8 April 2020

RESENE PAINTS LIMITED RESOURCE CONSENT VARIATION APPLICATION - DISCHARGE TO AIR: TECHNICAL REVIEW OF ASSESSMENT OF EFFECTS ON THE ENVIRONMENT

Figure 1: 1-hour Average MGLC Contours (Toluene)

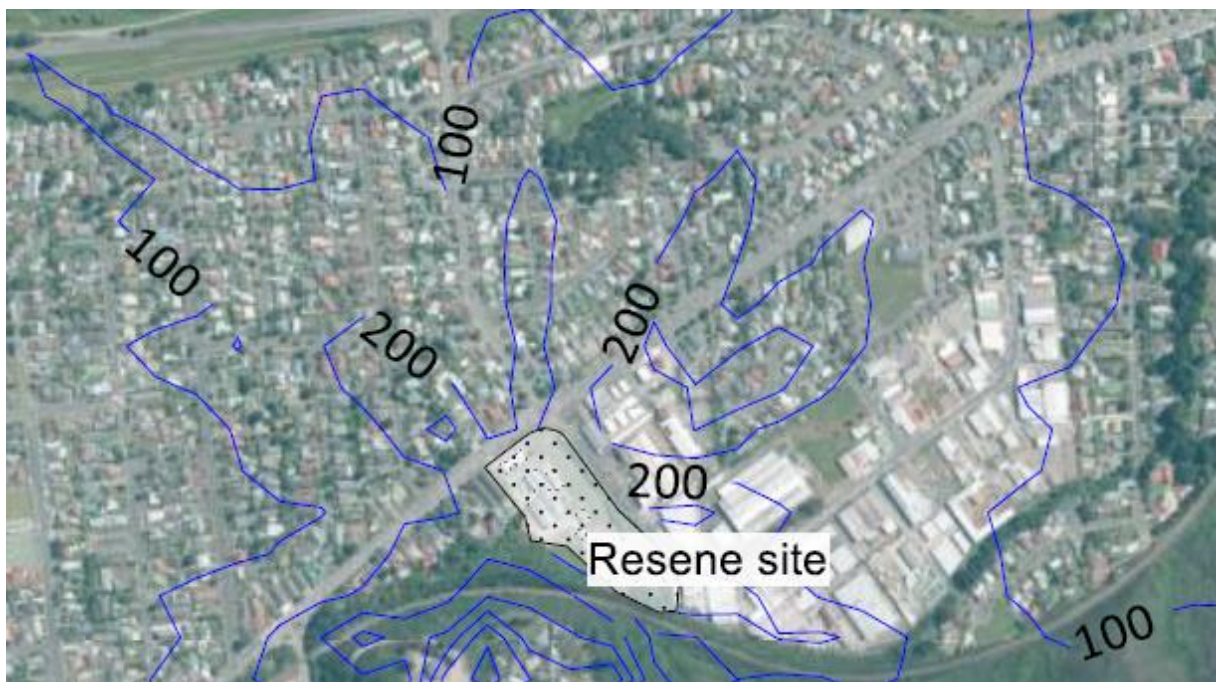
The majority of complaints centre on Mountbatten Grove. This is coincident with elevated 1-hour average concentrations caused by the grounding of the plume from the Resene discharge. Figure 1⁵ demonstrates the location of this elevated grounding (the 200 $\mu\text{g}/\text{m}^3$ isopleth line to the north-west) for Toluene. The same plume behaviour and relative high concentrations will occur for odour discharged from the site.

PDP disagree with the applicant's assessment which points to a different or closer source as the cause of the complaints. While it is likely that complaints may arise due to a number of sources in the area, there are demonstrable events where:

- ∴ Resene were in production.
- ∴ The complaint was downwind; and
- ∴ The location of the complaint is consistent with the general location of elevated contaminant concentrations in the 1-hour model scenario.

As such, we cannot agree with the applicant's assessment that the effects of odour will be less than minor.
